ADDENDUM NO. 1

**Administration Building Renovation Re-bid
Compton Community College District**

tBP Project. No. 20987.00

tBP/ARCHITECTURE

drawing no.:
ED-1

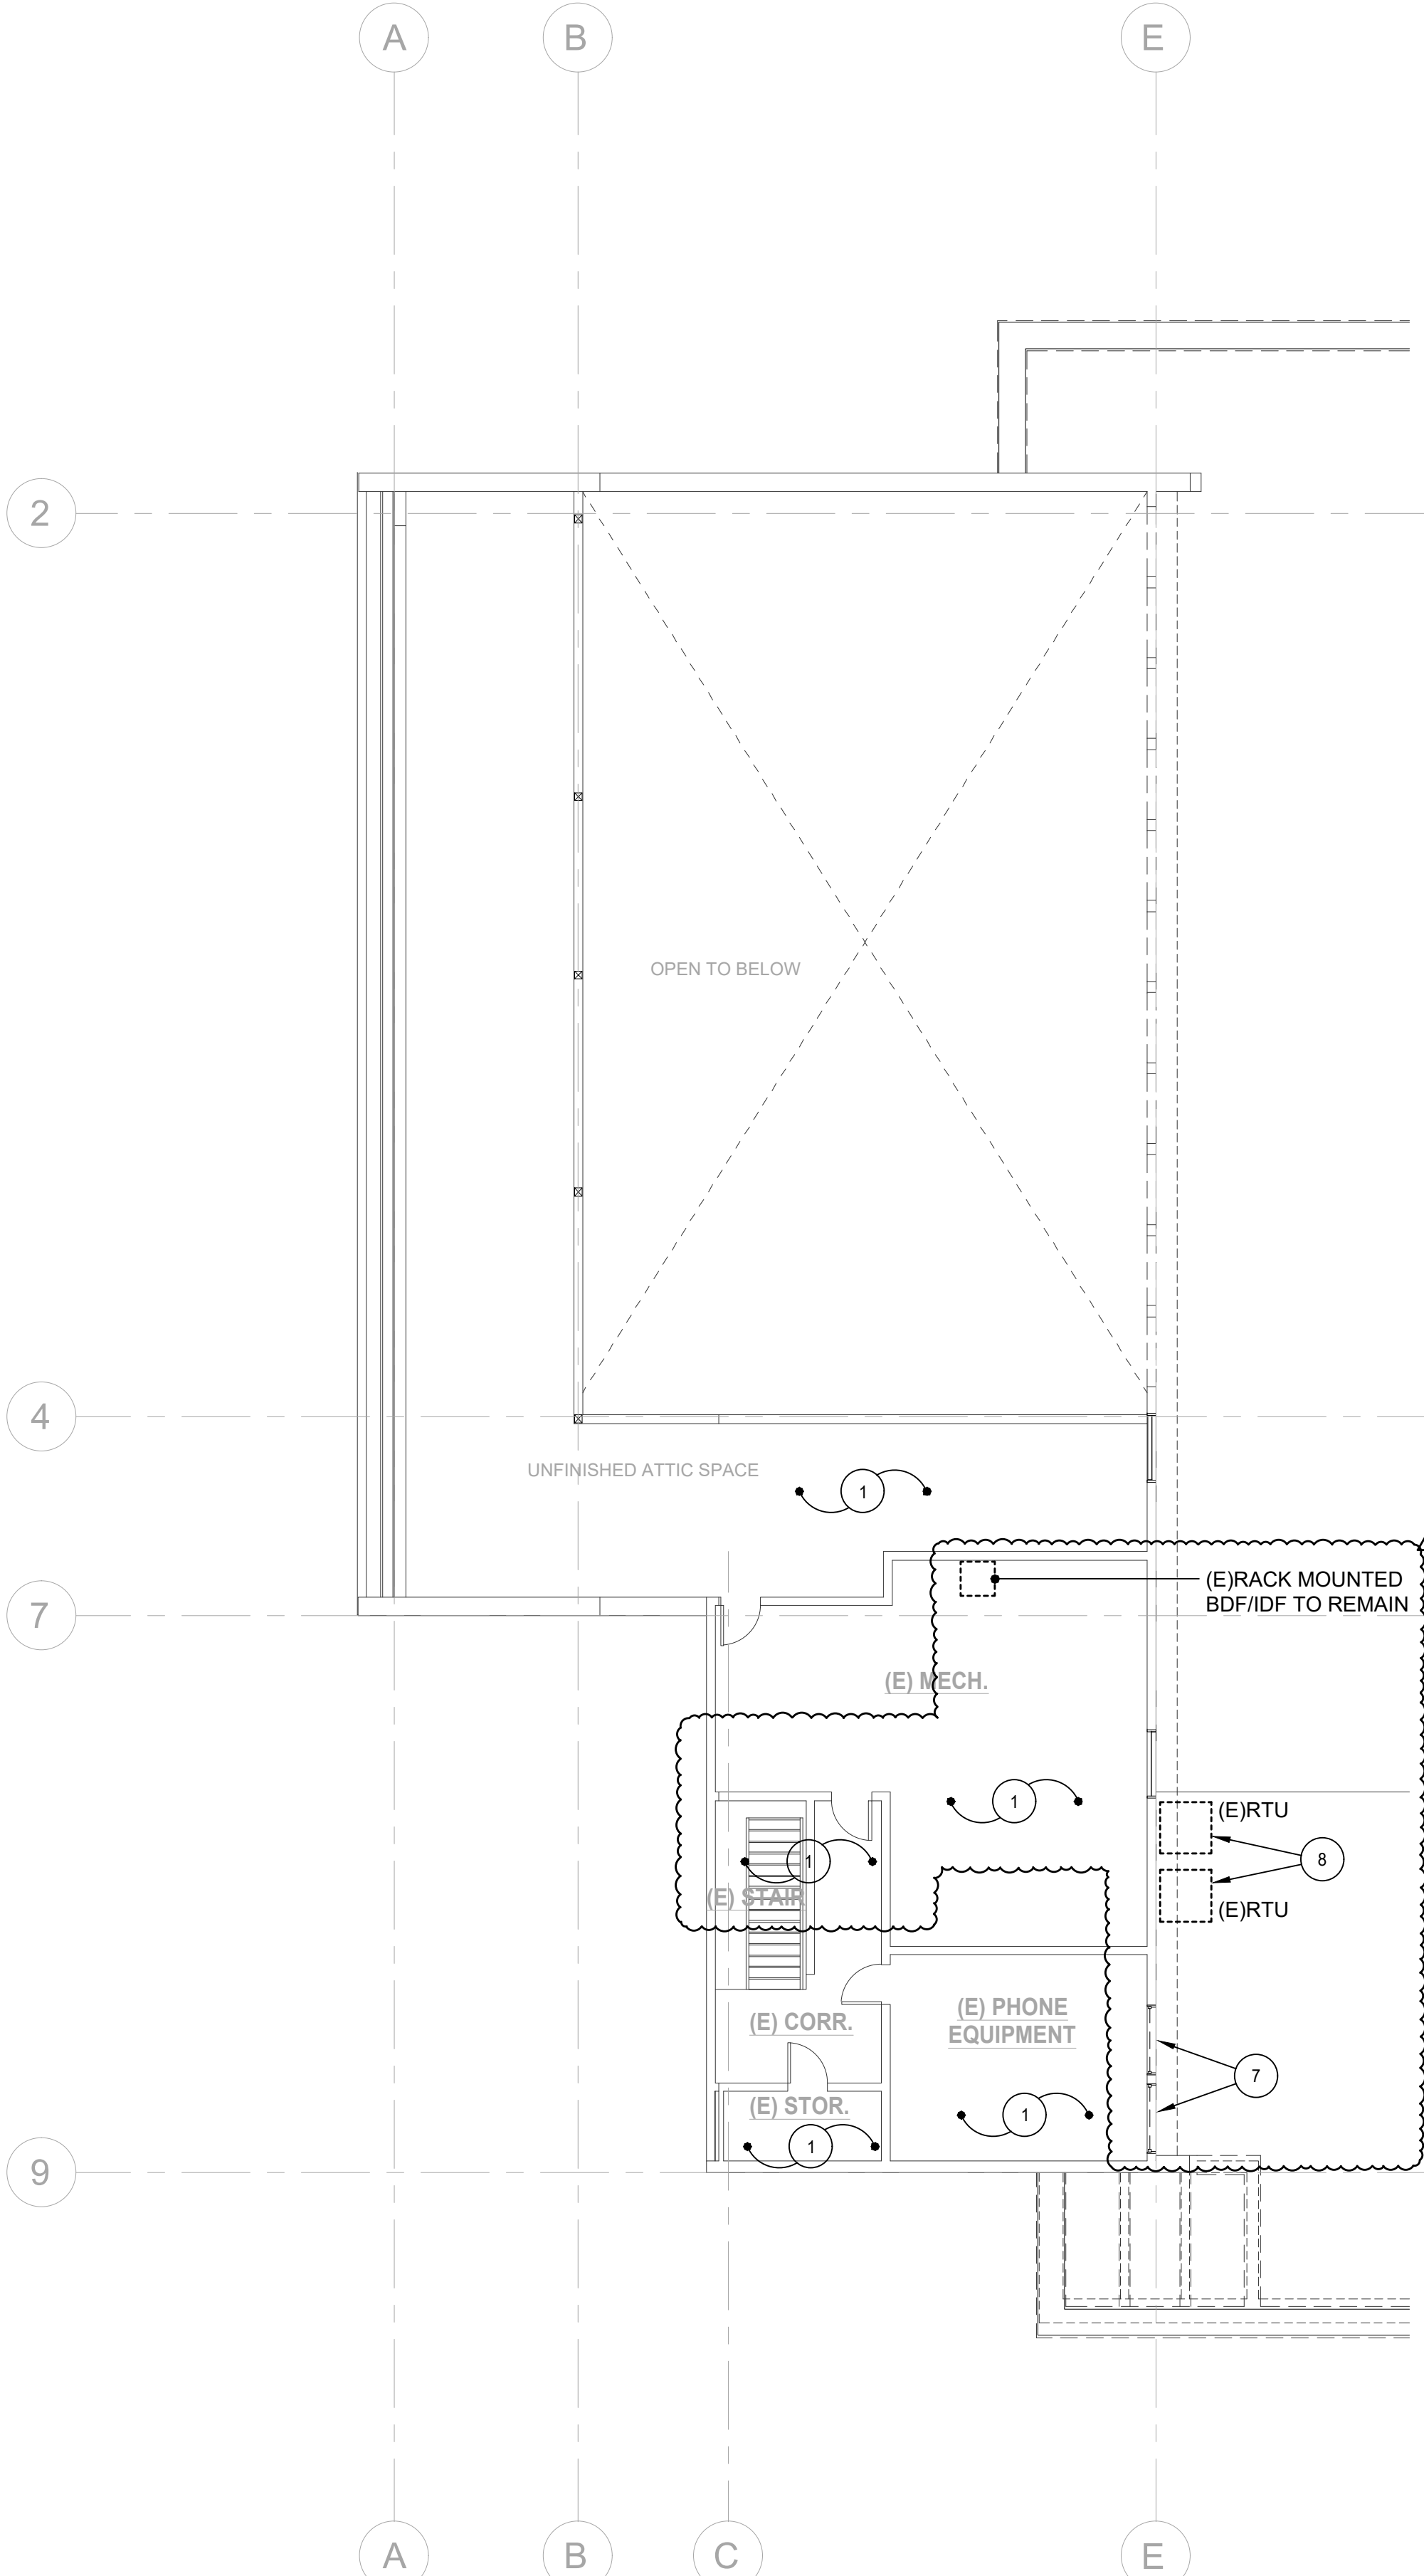
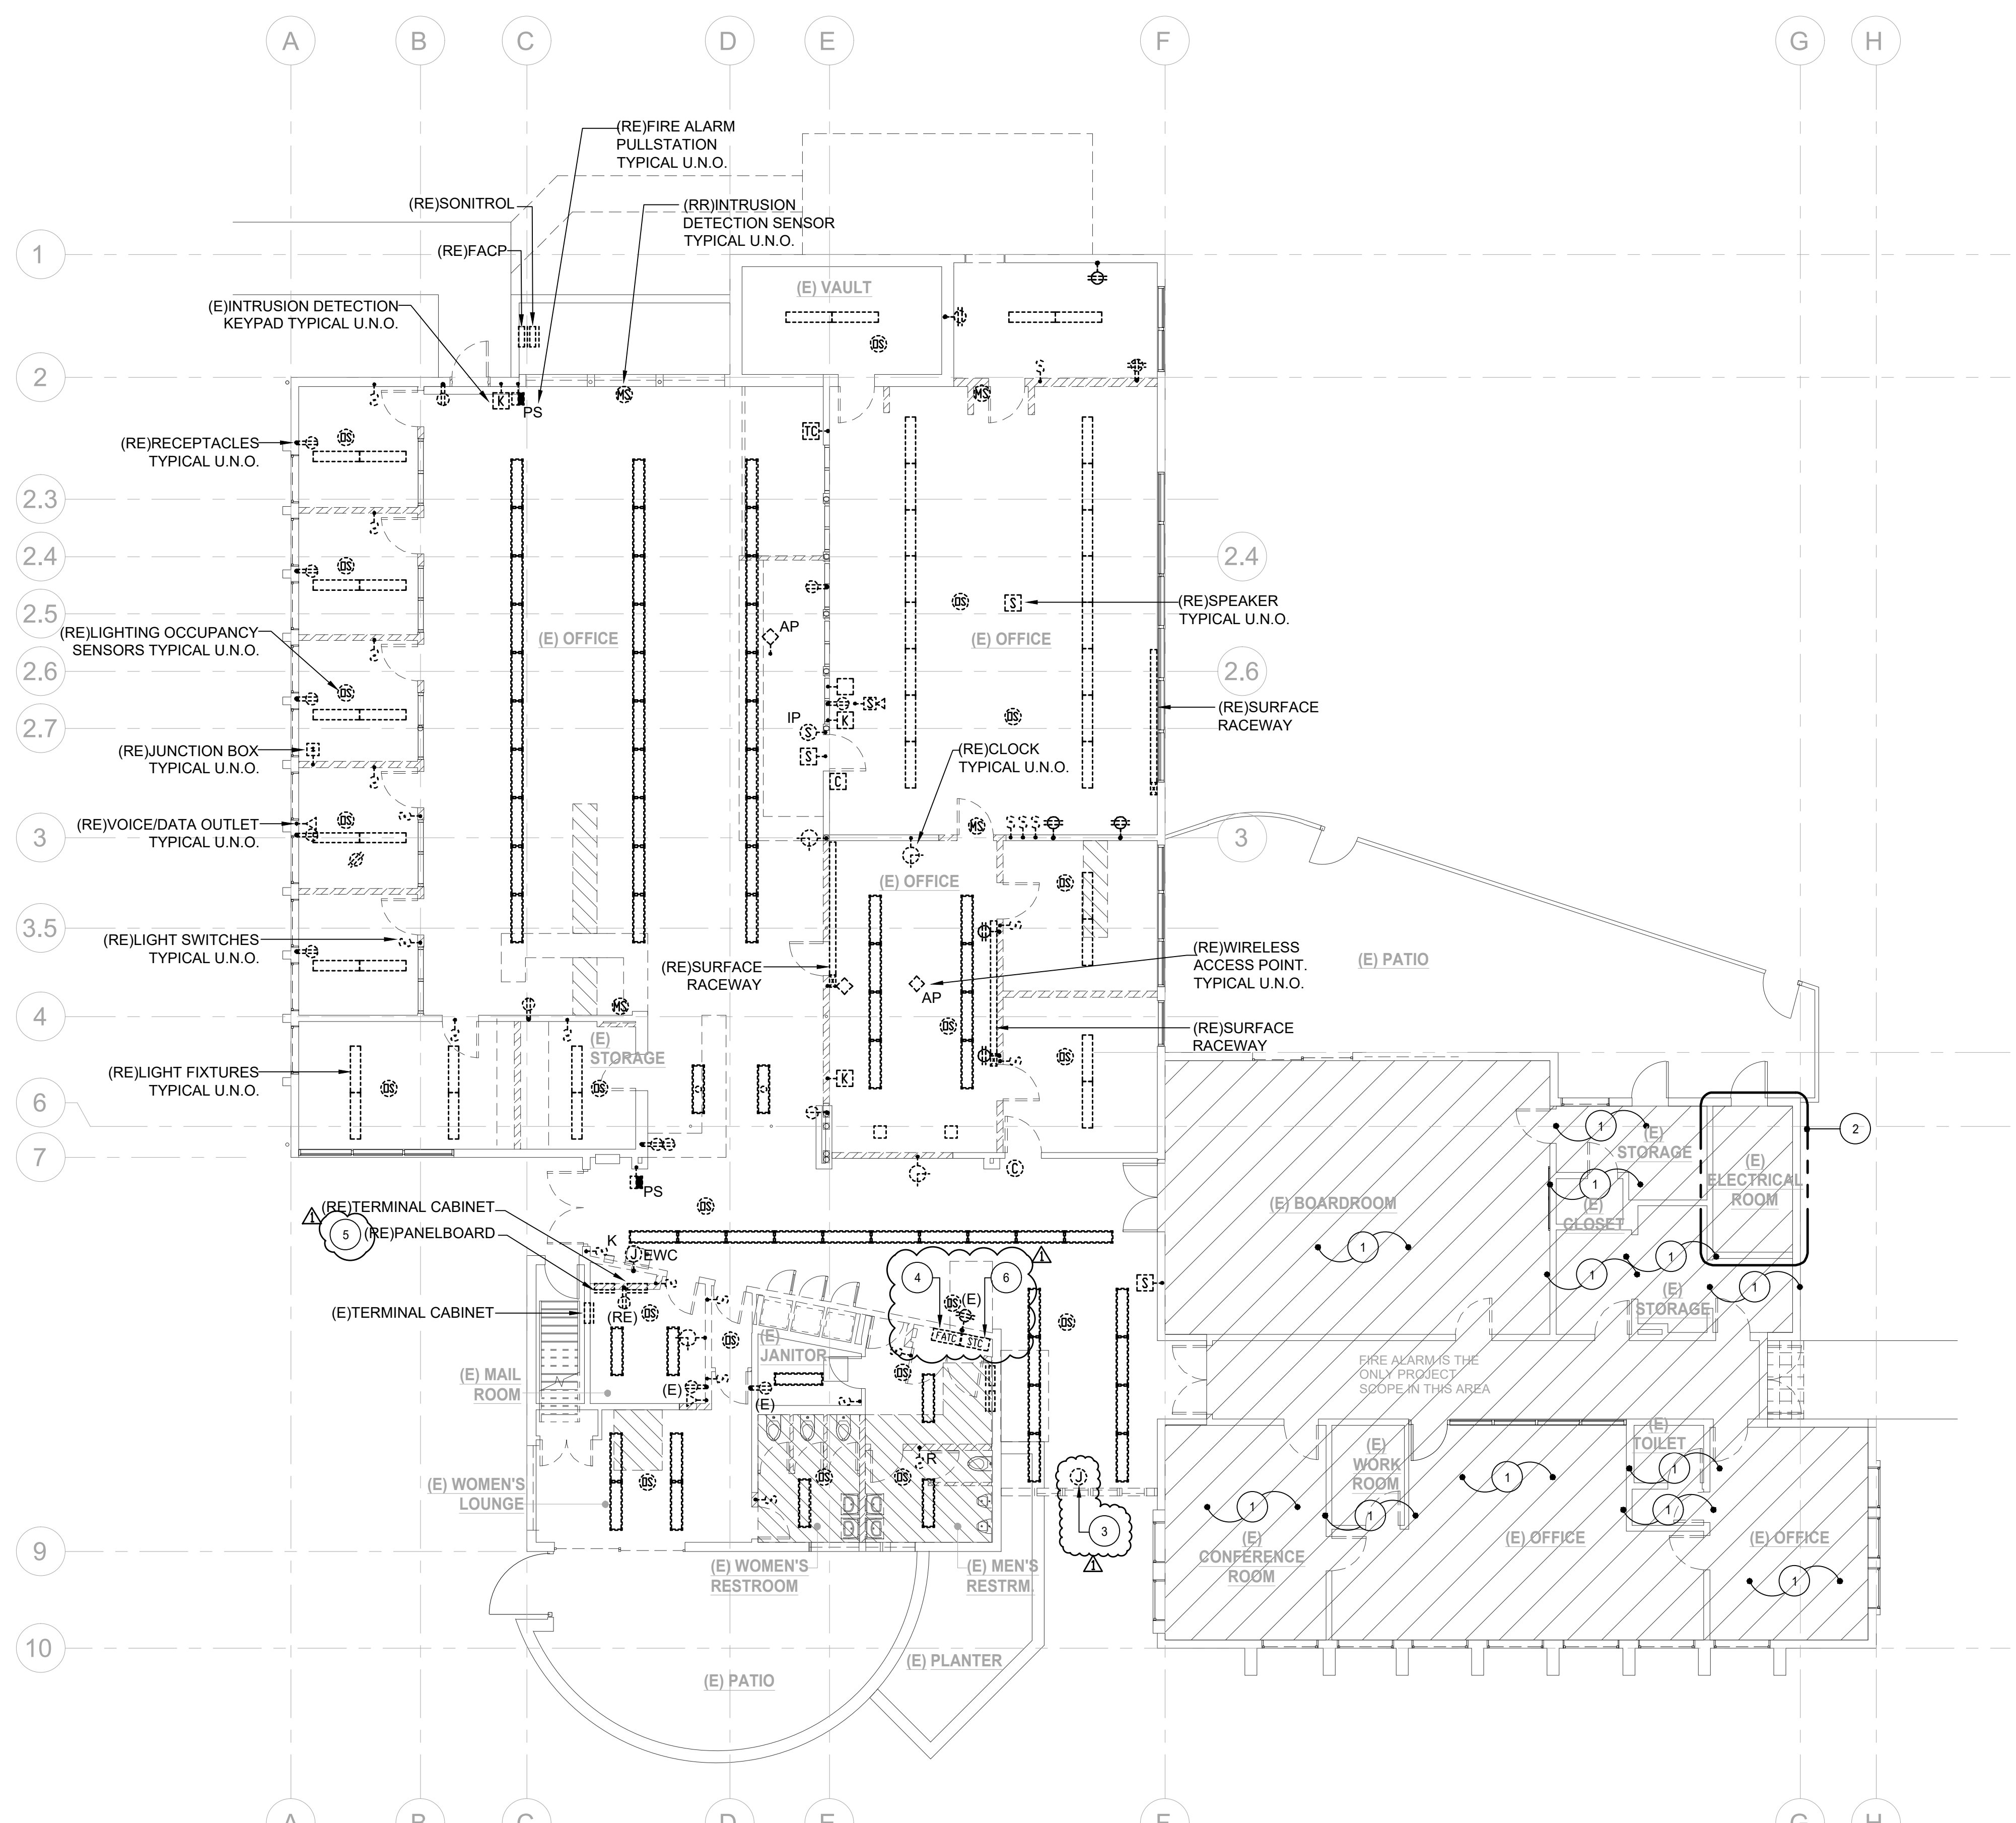
28. Revised Sheet ED-1 Demolition Electrical Plan

- a. Removed existing fire alarm and signal terminal cabinets.
- b. Removed existing power panel.
- c. Revised Plan Notes
- d. Removed power from window AC units.

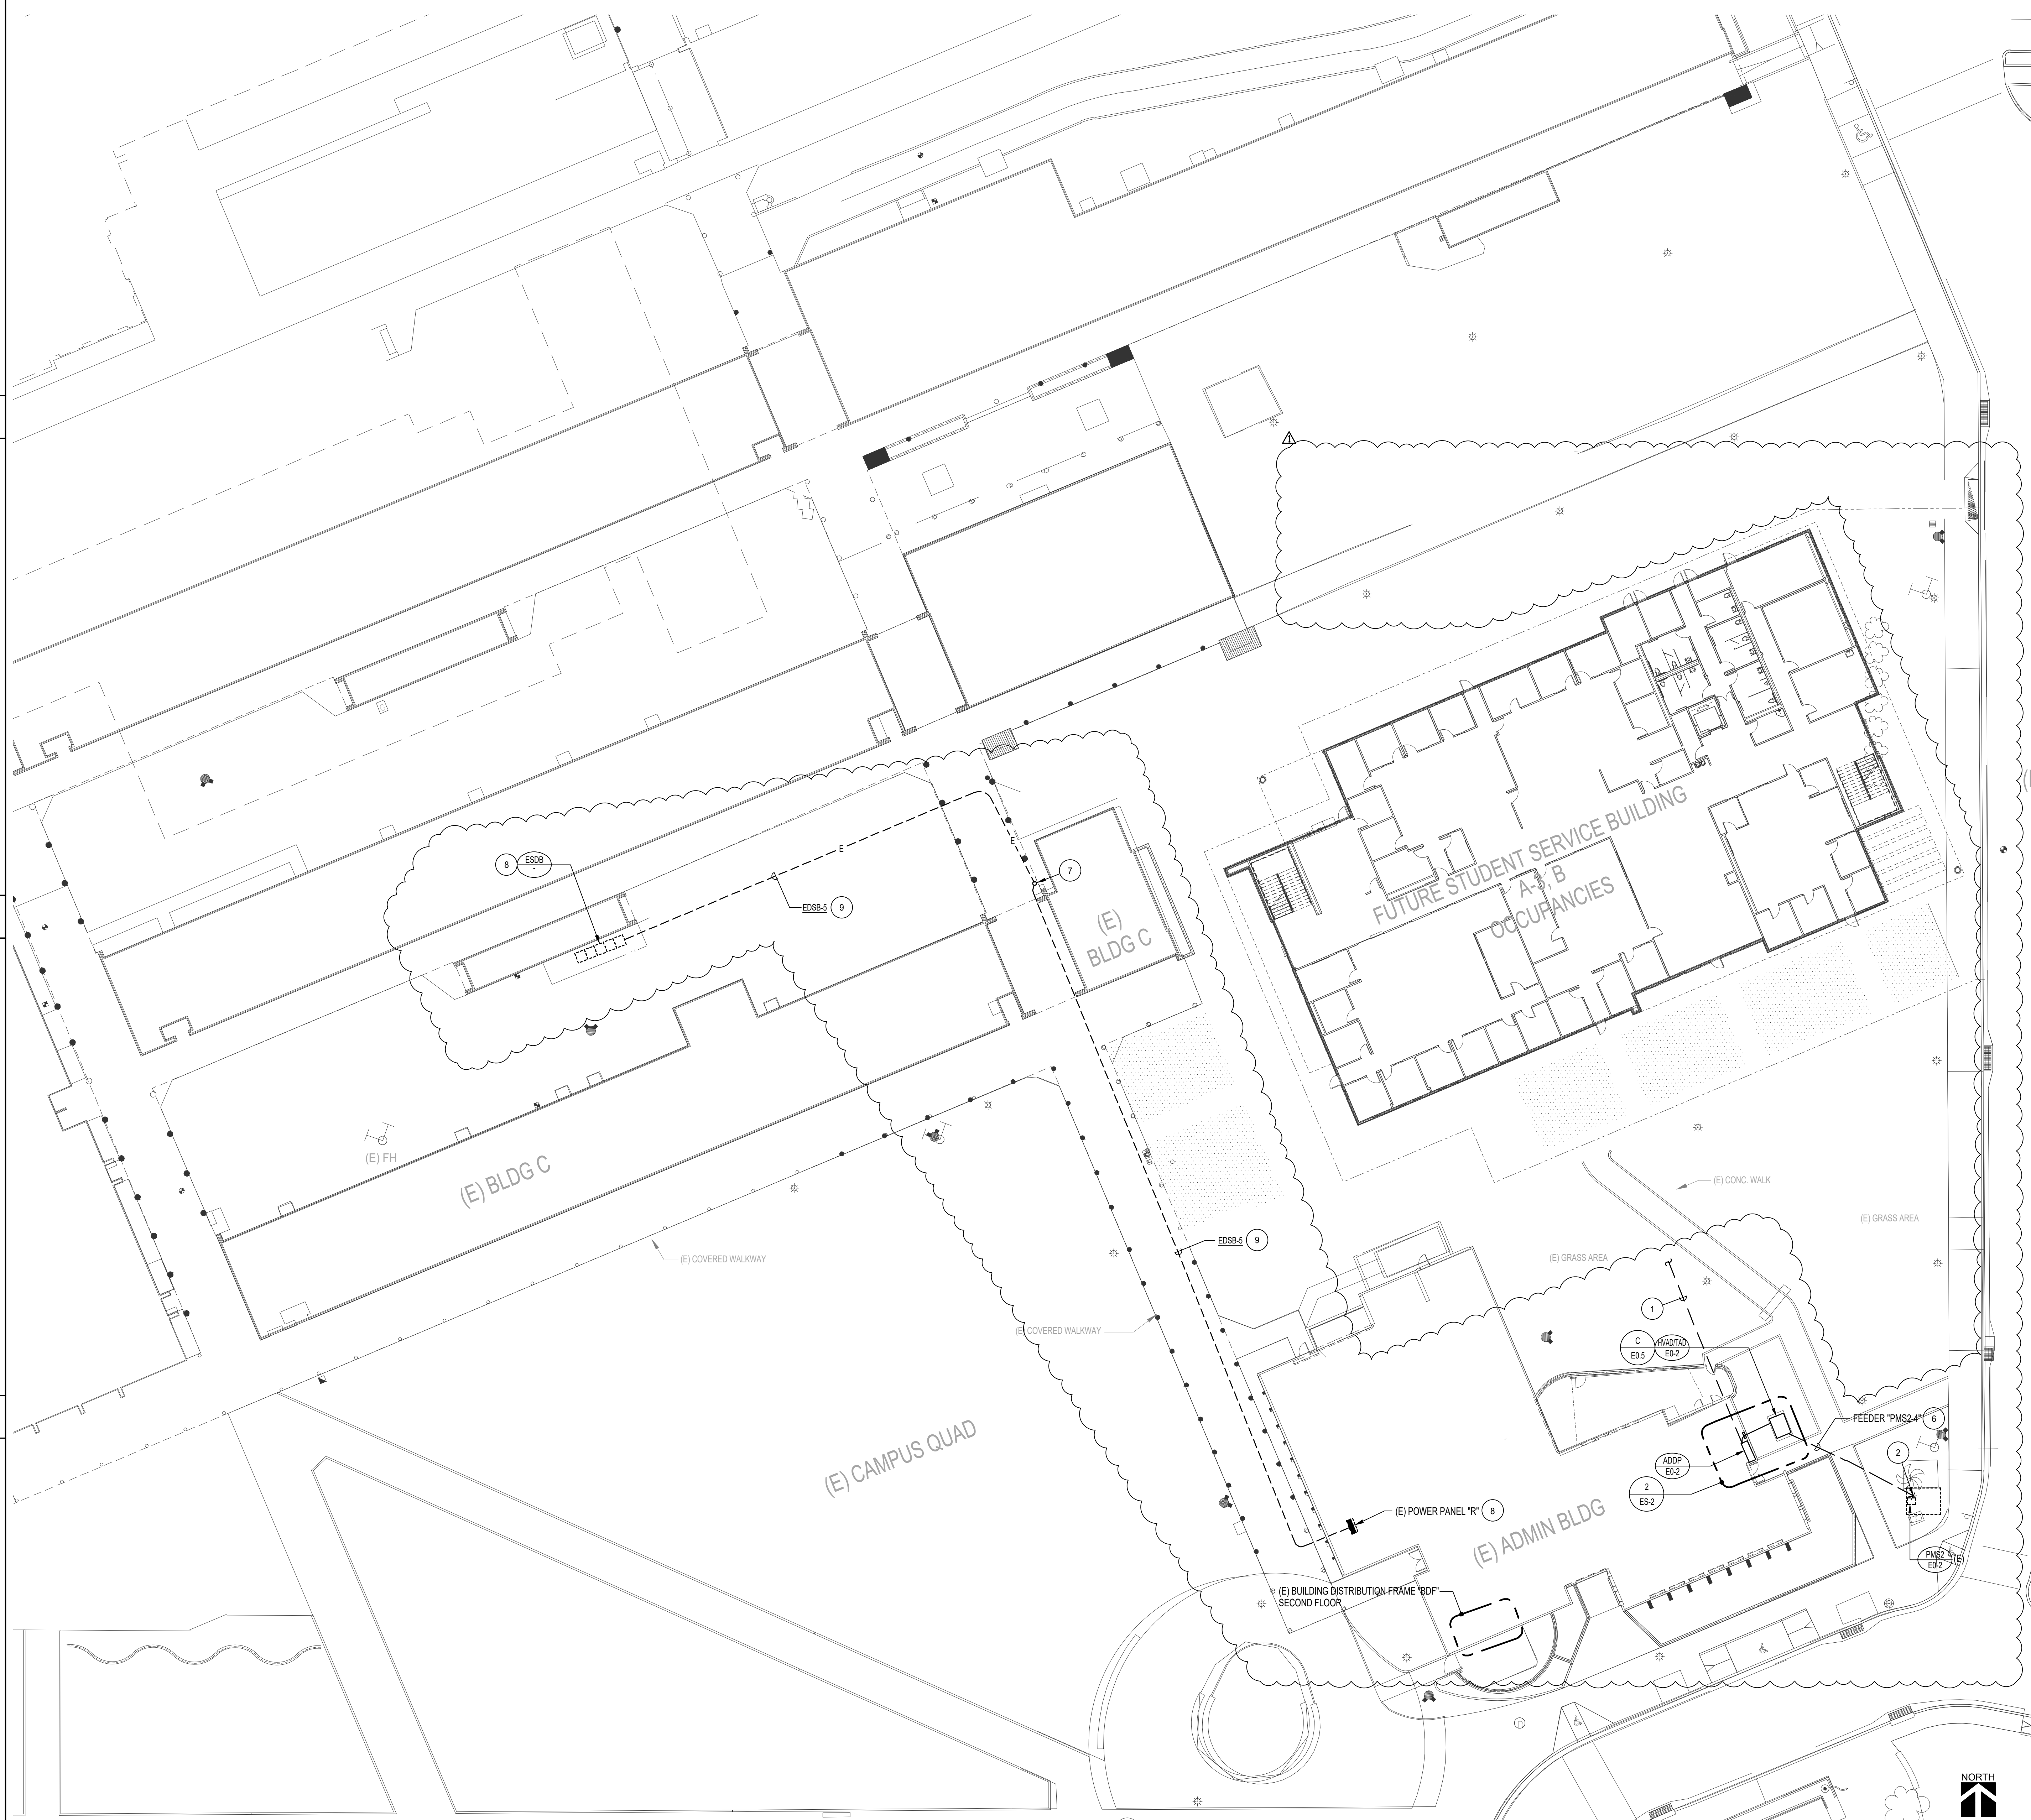
27 Revised Sheet ES-2 Enlarge Site Electrical Plan

- a. Revised power extension to Administration Building from existing high voltage switch.
- b. Show existing power feeder from existing switchboard EDSB to panel "R" to remain during modernization and to be removed after building's renovation.
